# Technical Bulletin

SUBJECT: PHILCO I.C.'s

N-Series

3/17/70

PHILCO

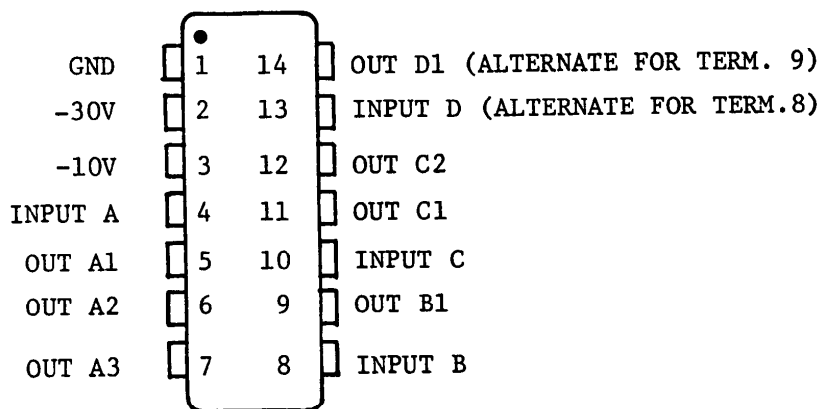
Since that time a second version of the Philco I.C. has been used in production. These are gold color instead of black, and may be used interchangeably with the black ones.

For proper orientation a dot appears in one corner of the top of the I.C.'s. The dot identifies the location of pin 1 (ground), as shown in the illustration below. The gold I.C.'s are not notched. The dot is the only guide.
